**FORT DEVENS
FEASIBILITY STUDY
FOR GROUPS 2 & 7 SITES**

**FINAL
FEASIBILITY STUDY REPORT
AREA OF CONTAMINATION (AOC) 43J**

ABB Environmental Services, Inc.
Wakefield, Massachusetts
Project No. 07053-11

FIGURE 2-1
DISTRIBUTION OF ORGANIC GROUNDWATER
CONTAMINATION ABOVE MCL ON 3/95
AOC 43J-HISTORIC GAS STATION J
FEASIBILITY STUDY REPORT
FORT DEVENS, MA

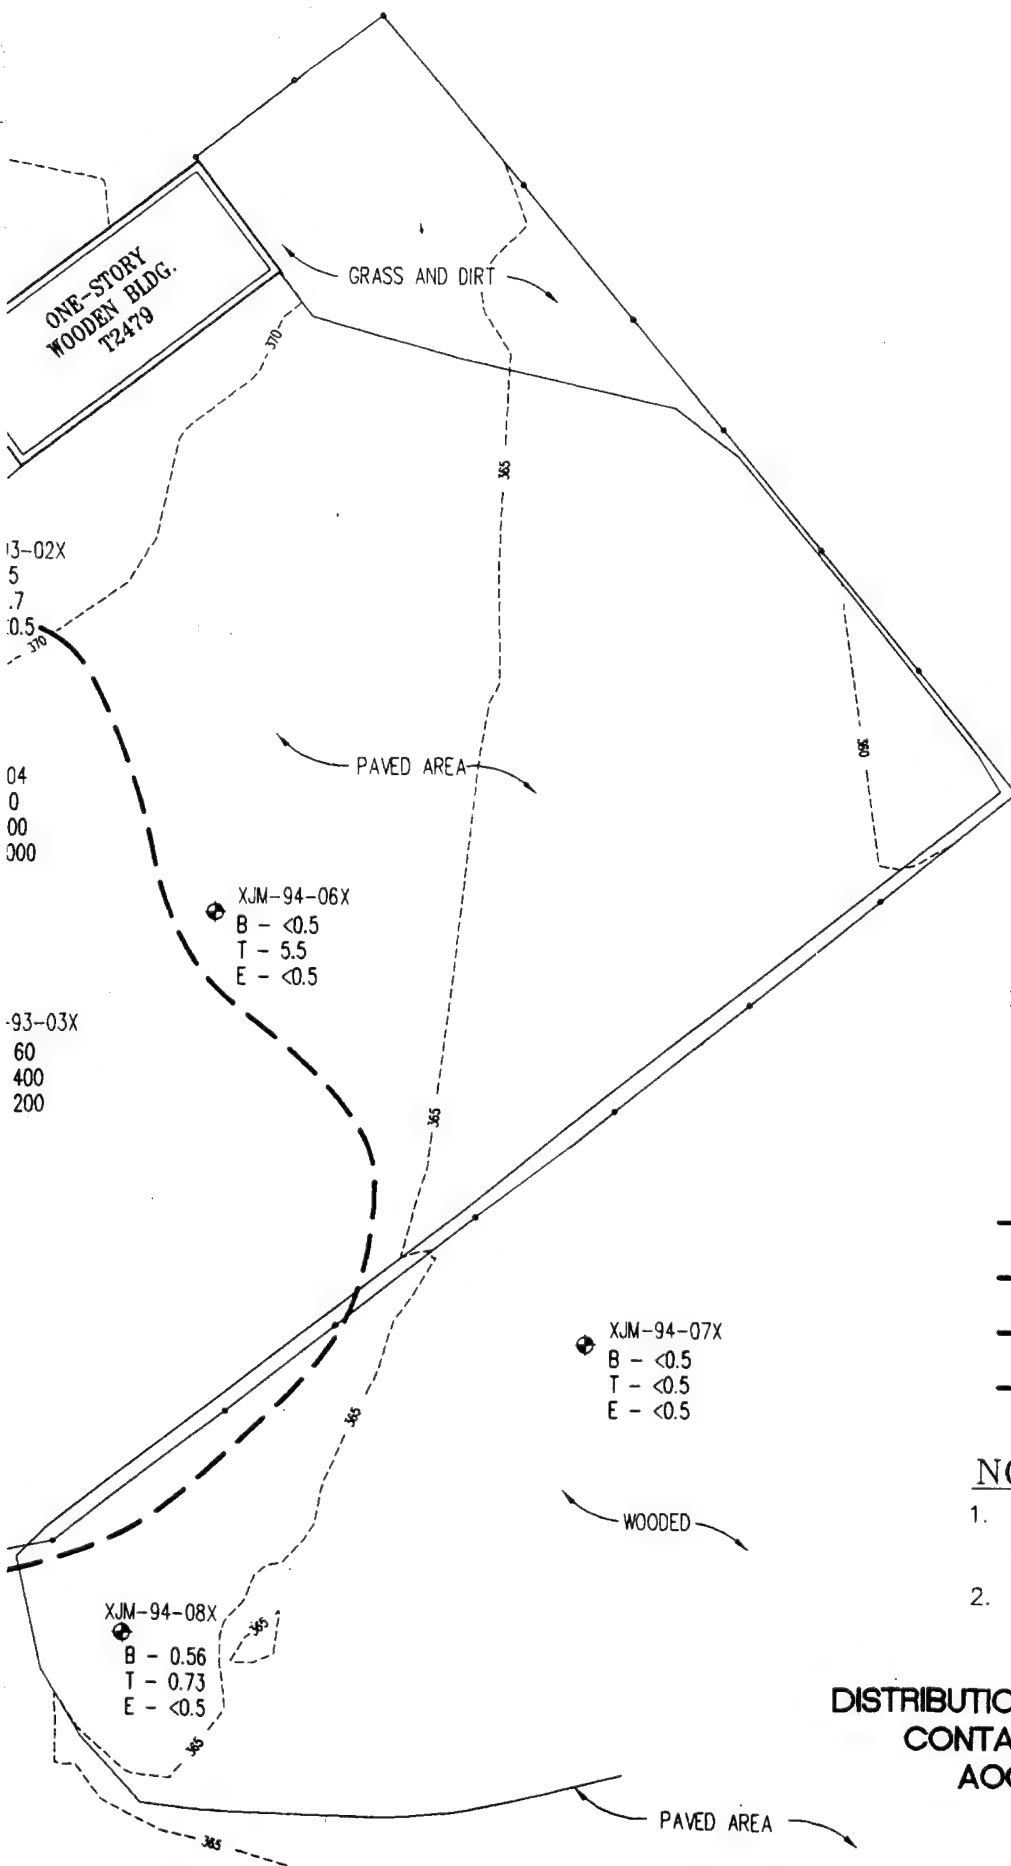
1. Comment: Establishing a case for intrinsic bioremediation (Table 2-3 and Figure 2-1 were consulted in formulating this comment). The demonstration of the occurrence of intrinsic bioremediation is insubstantial and contains inconsistencies. Table 2-3 shows the expected trend of increasing redox potential, increasing nitrate concentration, and increasing phosphate concentration moving down gradient from the source within the organic plume. However, the lowest sulfate concentration was observed at the down gradient edge of the plume rather than at the center of the plume. Furthermore, chloride concentrations, which should remain fairly constant within the aquifer, are significantly lower in the down gradient plume and down gradient edge. Thus, other phenomena may also be occurring which would then be obscuring some of the alleged biodegradation effects. Please address these inconsistencies in the FS.

FIGURE 2-2
DISTRIBUTION OF ORGANIC GROUNDWATER
CONTAMINATION ABOVE MCL ON 12/94
AOC 43J-HISTORIC GAS STATION J
FEASIBILITY STUDY REPORT
FORT DEVENS, MA

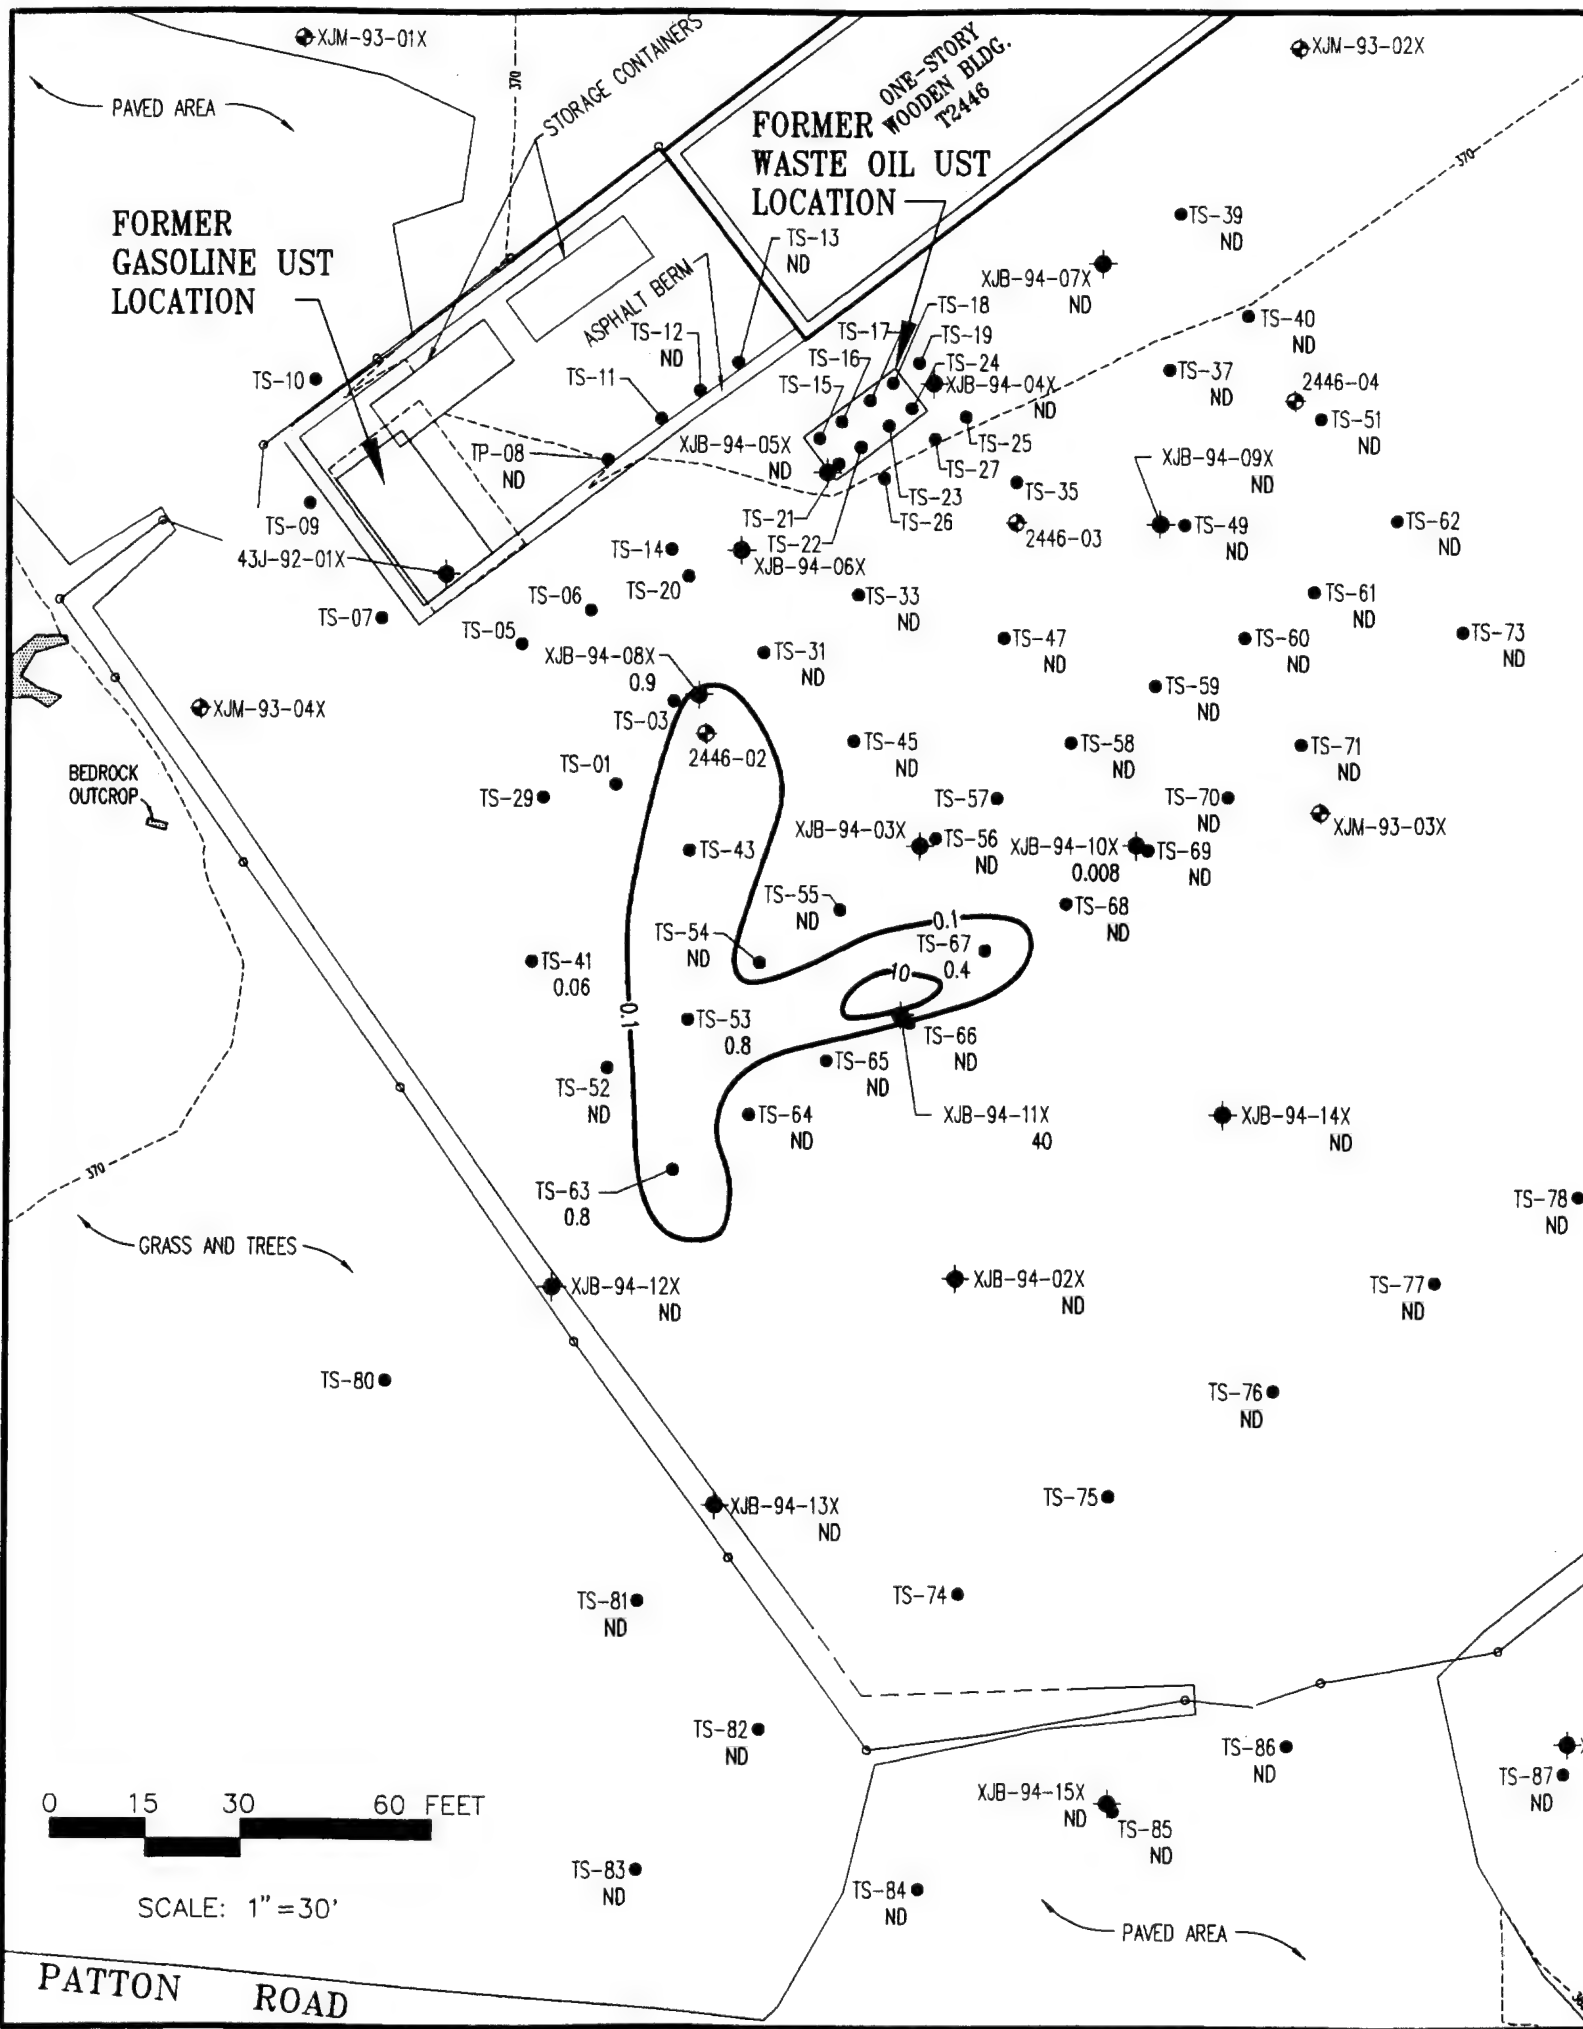
1. Comment: Establishing a case for intrinsic bioremediation (Table 2-3 and Figure 2-2 were consulted in formulating this comment). The demonstration of the occurrence of intrinsic bioremediation is weak and contains inconsistencies. The case for intrinsic bioremediation is made based solely on indirect evidence. Table 2-3 shows the expected trend of increasing redox potential moving down-gradient from the source within the organic plume. However, the lowest nitrate, sulfate, and phosphate concentrations were observed at the downgradient edge of the plume rather than at the center of the plume as would be expected. This is inconsistent and requires at least a speculative explanation. Furthermore, chloride concentrations, which should remain fairly constant within the aquifer, are significantly lower in the upgradient well. Thus, other phenomena may also be occurring which would then be obscuring some of the alleged biodegradation effects. This inconsistency should be addressed.

Response: Because the "source area" wells may actually be slightly upgradient of the true center of the plume (as noted by the soil concentration contours in Figure 2-3 through 2-8), nitrate, sulfate and phosphate concentrations may decrease farther downgradient as appears to be observed in downgradient wells. Lovely, Chapelle, and Woodward (Lovely, 1994) note that when shallow aquifers are heavily contaminated with organic compounds, it is generally difficult to delineate the distribution of the anoxic redox processes. They further state that reduced products that are actively produced near the source of organic contamination may persist in the groundwater as it moves downgradient into areas where there is little or no ongoing production of these compounds. Therefore observation of reduced nitrate, phosphate and sulfate are not necessarily inconsistent with expected trends and does not negate the evidence that biodegradation is occurring at the site.

FIGURE 1

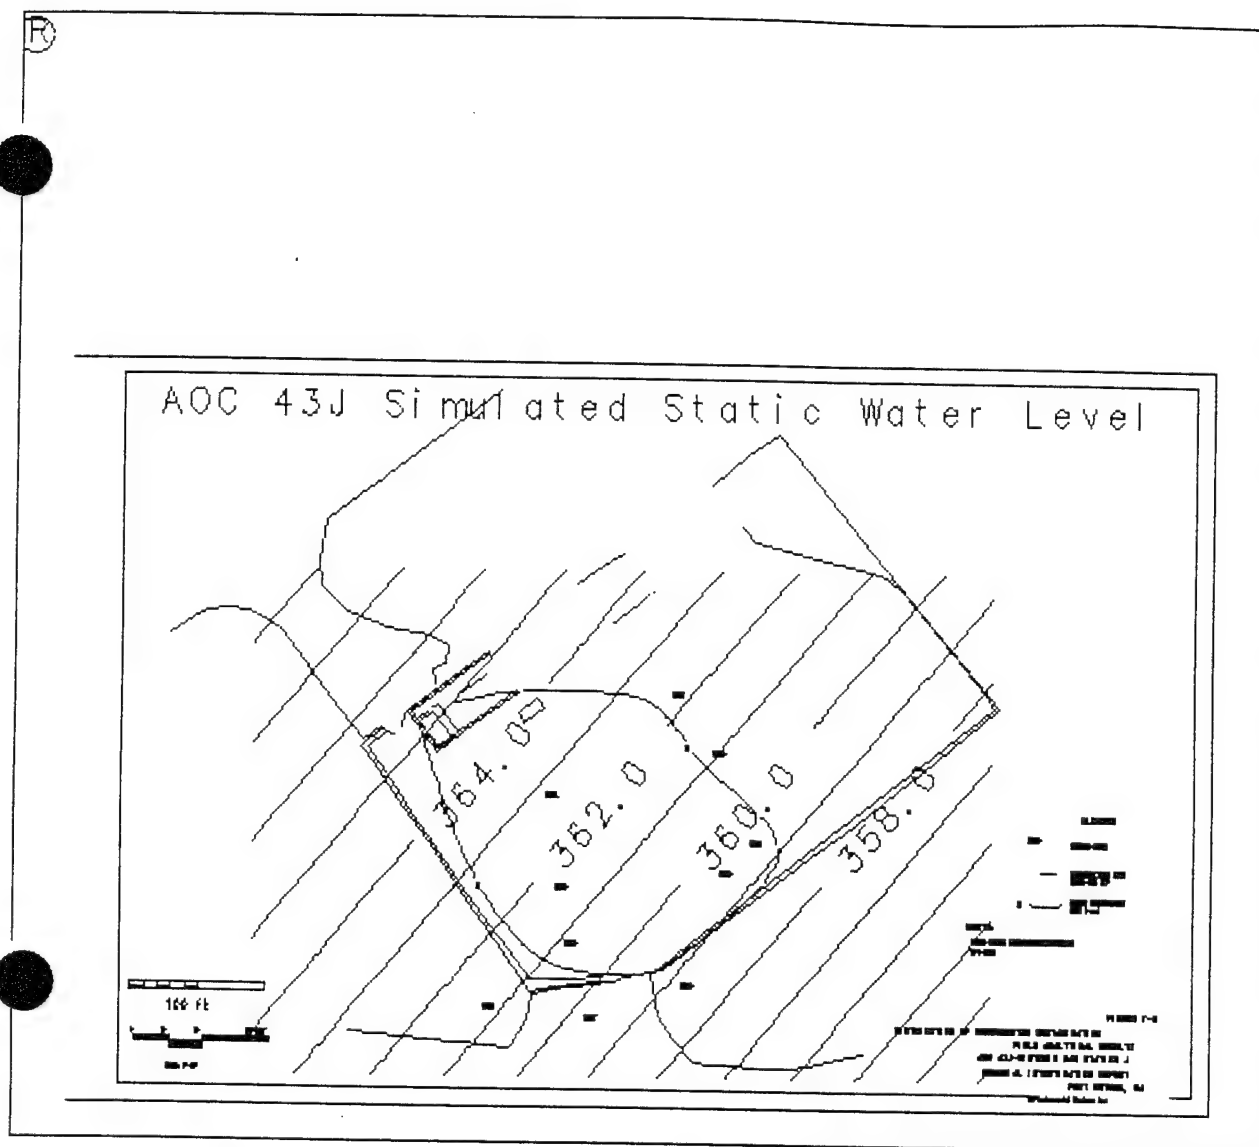
13. Comment: **Appendix B, Figures 1, 2, & 3.** Much of the text and characters in these figures are illegible. These figures should be presented in a larger format.

Response: The Quickflow model's graphics resolution using converted Autocad drawings as presented in Figures 1, 2, and 3 cannot be improved. All the relevant data for review of the model output (well location, groundwater elevations, and flow) are clearly depicted. The remaining typed text or site features that are lost due to poor resolution are not pertinent to the overall model evaluation.

FIGURE 2

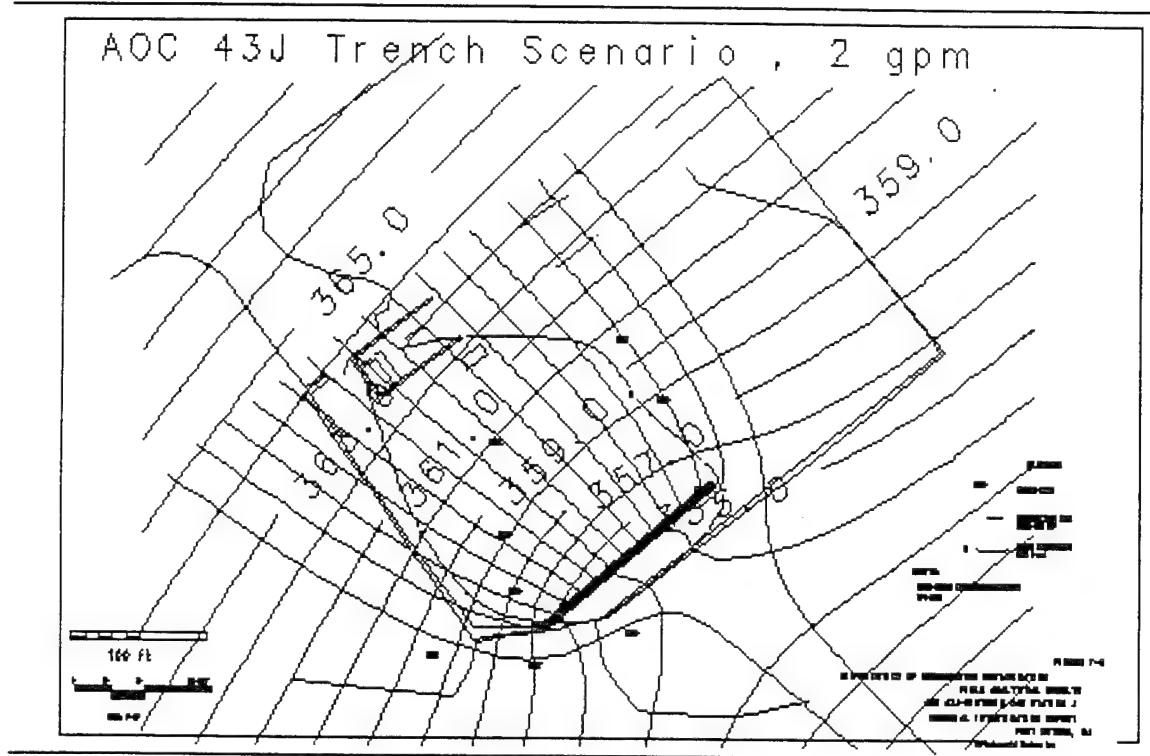
12. Comment: **Appendix A. Figure 2:** The groundwater contours produced under pumping conditions indicate the groundwater table will be at or below the bedrock/overburden contact in the area of the pumping wells. It appears the overburden will be dewatered and the wells will be collecting groundwater controlled by the bedrock geology (i.e. fractures, joints, etc.). As indicated in the pump

Figure 2 needs to be revised such that the elevations of the contours are legible and the identities of the wells used to generate the contour are shown.

Figure 2 contour elevations will be made more legible. Identifying specific wells would only make the figure less legible. Figure 2 states that contours are based on the May 9, 1995 water level measurements. The reader can readily reference Figure 1-10 for monitoring well identification.
